Paul A. Rubin, Hydrogeologist

May 5, 2020

Surface Hydrology, Hydrogeology, Bluestone Quarries, and Glacial Geology Proximal to Pickerel Pond and the Proposed 850 Route 28 Manufacturing Facility

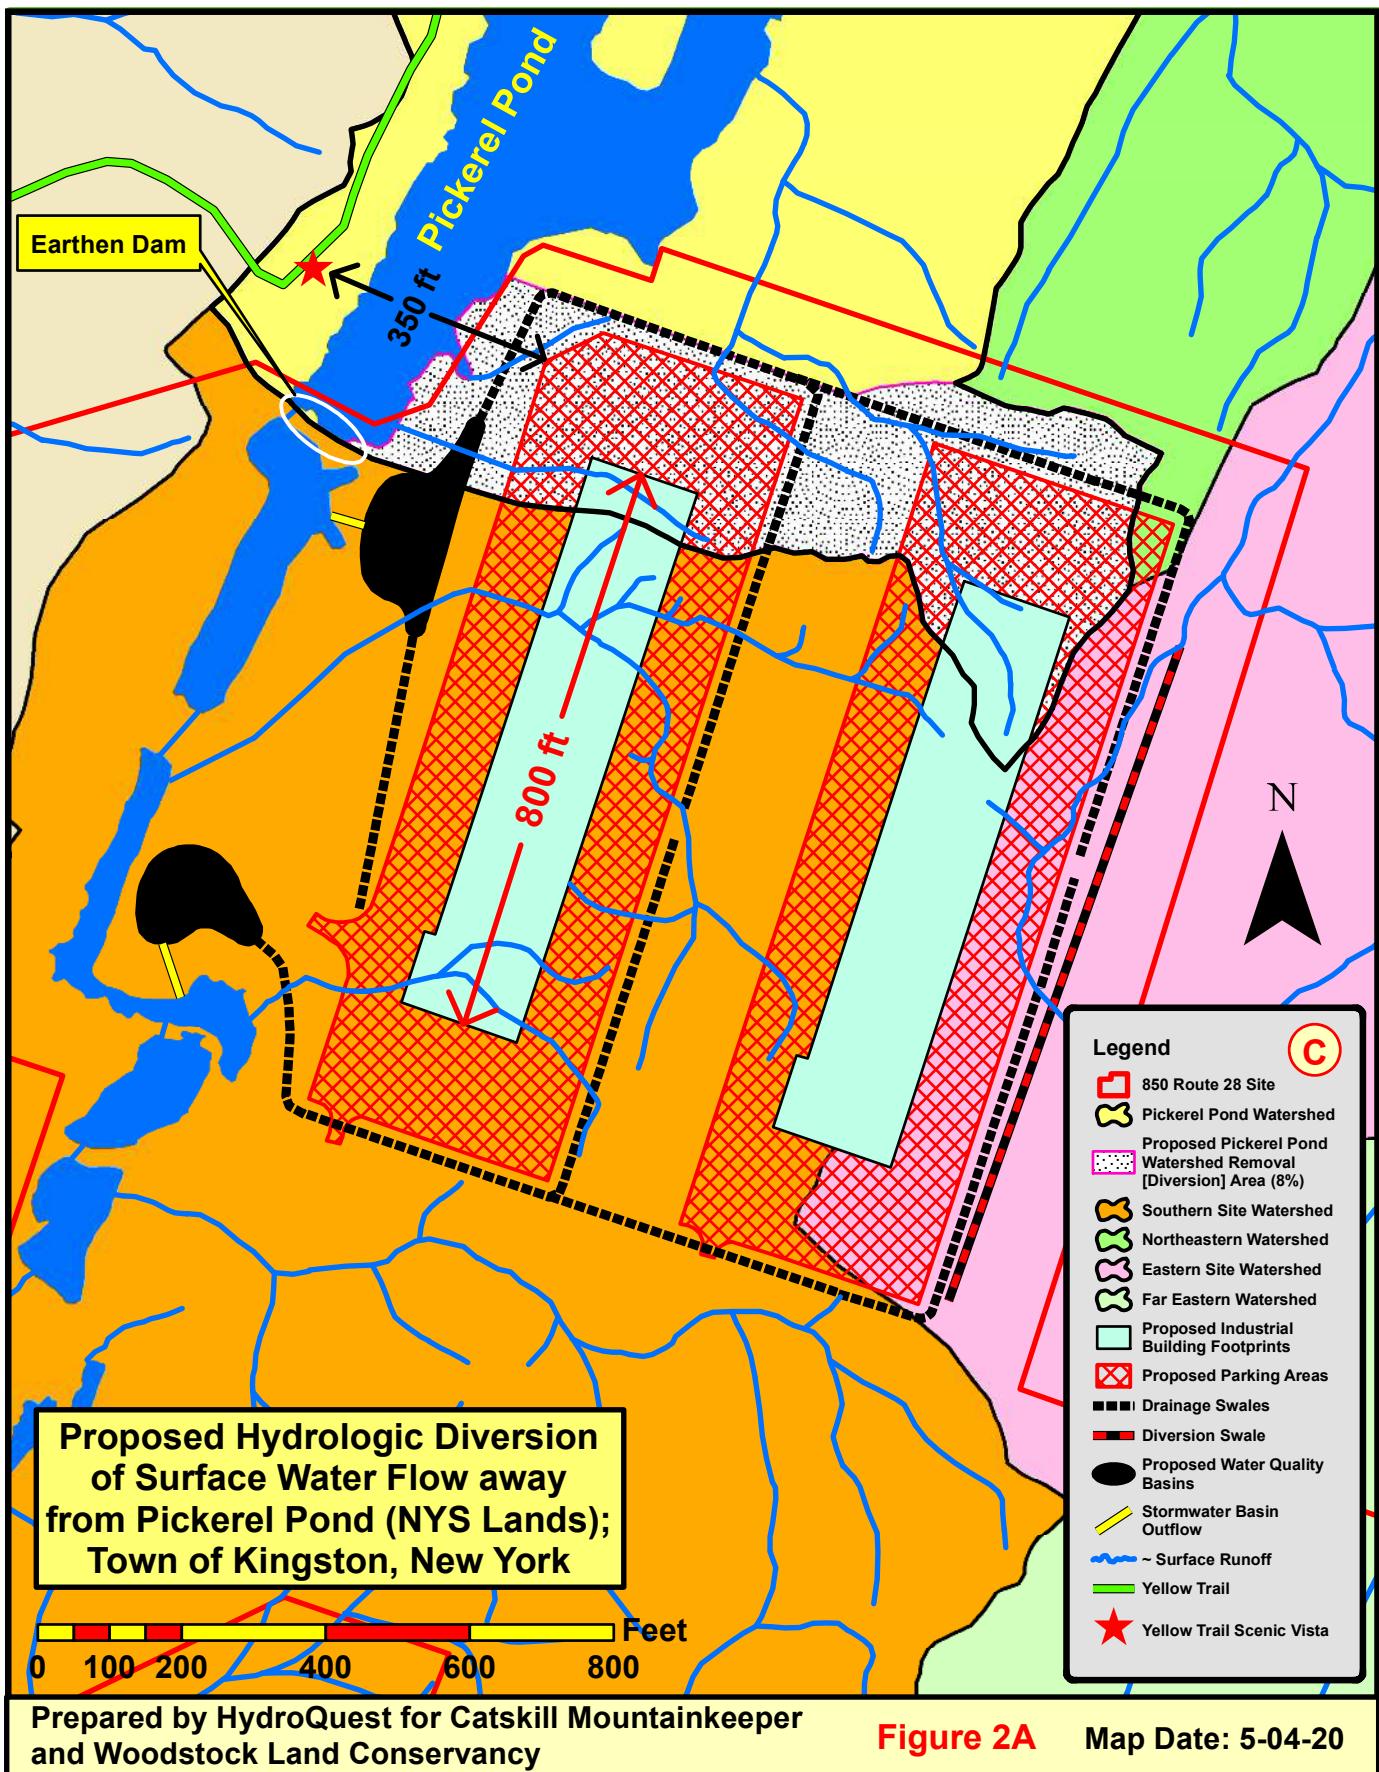
- The proposed 850 Route 28 manufacturing facility straddles a hydrologic divide (see [Figure 1](#)). The southern site, Pickerel Pond, and Onteora Lake watersheds drain southward through a large wetland complex (NYS DEC Wetland KW-3) and then as Praymaher Brook alongside Thielpape Road until flowing into Esopus Creek.
- The northeastern, eastern, and far eastern watersheds drain northeastward as a stream until a confluence with the Sawkill northeast of Jockey Hill. The Sawkill then flows southeastward until it joins the Esopus Creek which then flows northward to Saugerties where it discharges into the Hudson River. The distance along the Sawkill and Esopus Creek between where project site drainage enters them is 10.3 creek miles.

- Figures 1 and 2 show the proposed 850 Route 28 project parking and building areas extending into the Pickerel Pond watershed. Field reconnaissance conducted on March 1, 2020 found only two of six streams actively flowing into the northeastern end of Pickerel Pond. Their combined discharge was estimated as only 25 gallons per minute (Photos 7 and 8). It is highly likely that there is no surface inflow during dry and drought times both here and immediately downstream of the earthen dam. This is important from the perspective of potential dilution and assimilation of chemical contaminants and stormwater runoff that the manufacturing facility may discharge into the waterway. The extreme headwater setting of the proposed industrial facility will, at times, have no natural streamflow.

- While the hydrologic impact to Pickerel Pond would be significant, reference to Figures 1 and 2 reveals that project construction would also result in disruption of surface flow in other watersheds straddling the hydrologic divide discussed above.
- A significant portion of the northern project area was clear cut of trees sometime between 2016 and late 2019, as shown on 9-18-19 Google Earth imagery. This area encompasses both the proposed project site and tributaries to Pickerel Pond. Large felled trees are present within the proposed industrial development area (Photos 9a and 9b). Clear cutting typically results in increased runoff and sediment load and forest fragmentation.

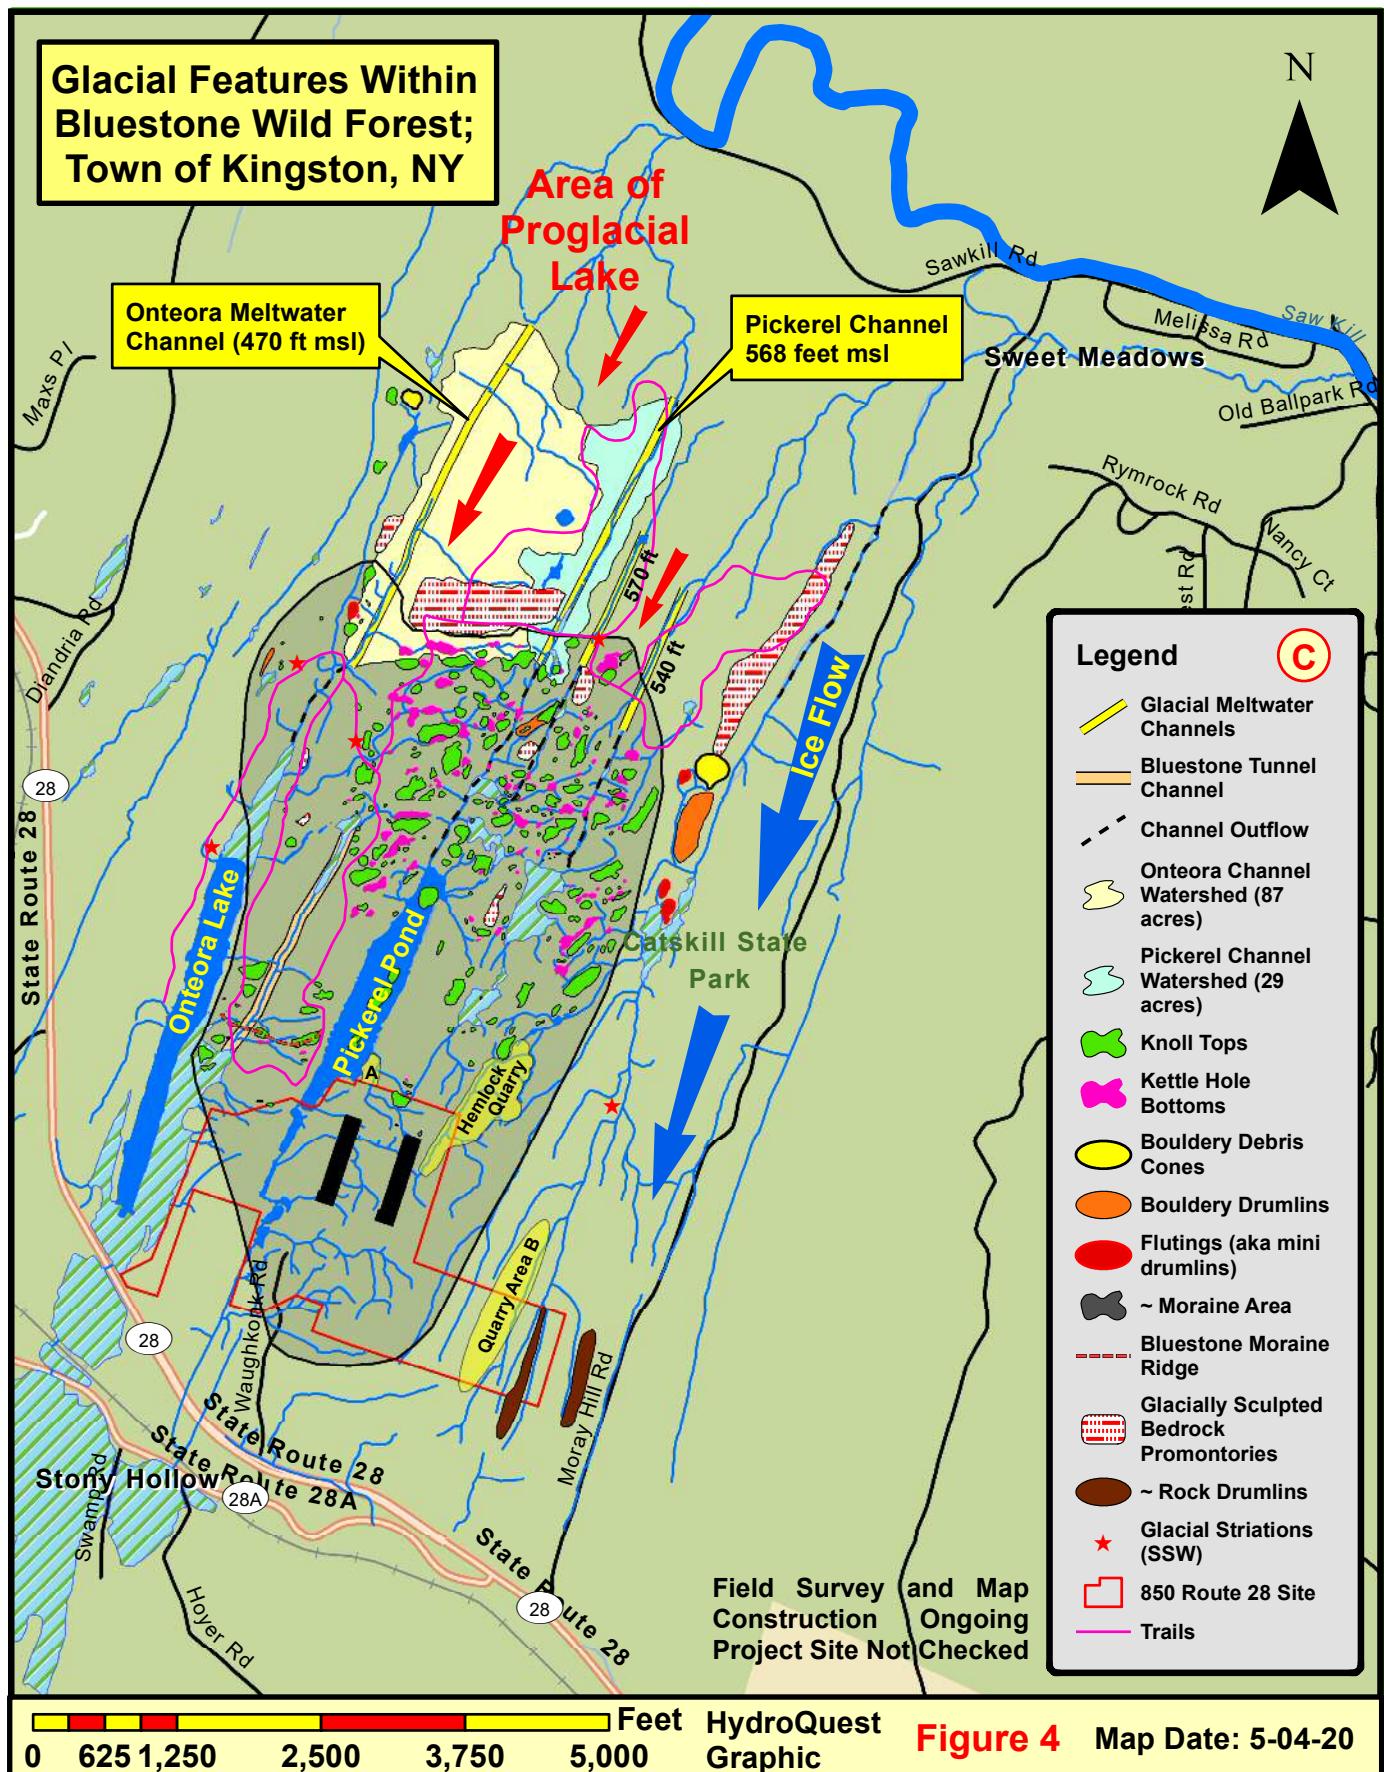
- The MHI well test was conducted on a single 273-foot deep bedrock well for only 24 hours with no observation wells. The well was pumped at a rate of 5.26 gallons per minute and resulted in a drawdown of 26.71 feet at the well. This contrasts with an MHI modeled drawdown of 11.4 feet at yet to be installed well BW-2 ([Figure 3](#)) at the stated project water demand of 2.0 gpm. The drawdown values portrayed in this figure would be larger, as would the cone of pumping influence (i.e., depression), if industrial project demand were to be greater than the applicant's stated demand of 2.0 gpm (2,900 gpd).

- Well BW-1 is approximately 175 feet west of the nearest pond (Figure 3). Unless special permission was obtained from the local Department of Health (DOH) to modify this test, DOH guidance calls for a minimum test duration of 72 hours to assess potential aquifer boundary and safe yield limitations. Longer test durations provide a means of assessing increased aquifer drawdown as the cone of depression expands outward from a pumping well.

- The water level in well BW-1 (Figure 3) was found to be below the level of the nearby pond and surface waterway. This implies that groundwater in this well is under confined conditions, meaning that it is not directly connected to the nearby surface water. While this condition is present in the valley bottom, it is highly likely that up-valley and upslope fractures in the bedrock are open to infiltration of surface runoff that recharges the underlying aquifer that the project seeks to withdraw groundwater from. This natural continuum from upslope unconfined recharge conditions to valley bottom confined conditions is common. It is important to recognize this because pumping of project site wells will draw groundwater into them that may otherwise have contributed to and helped

- Figure 3 depicts MHI's modeled groundwater drawdown outward from one existing site well and two proposed site wells as predicted at 180 days under continuous pumping conditions at a daily use rate of 2.0 gpm with no recharge. This impact extends beneath homes, wetlands, streams, Onteora Lake, and Pickerel Pond. While the impact to homeowner well water levels would be small, the impact to surface water inputs to Pickerel Pond and to its shallow depth may impact its ecology.
- The project applicant documents that, at times, Pickerel Pond has no outflow. For example, text in the applicant's materials (page 20 of 28 of a revised 2-26-20 document titled: NYS Environmental Quality Review Act EAF Addendum for 850 Route 28 LLC Proposed Manufacturing Facility) states:
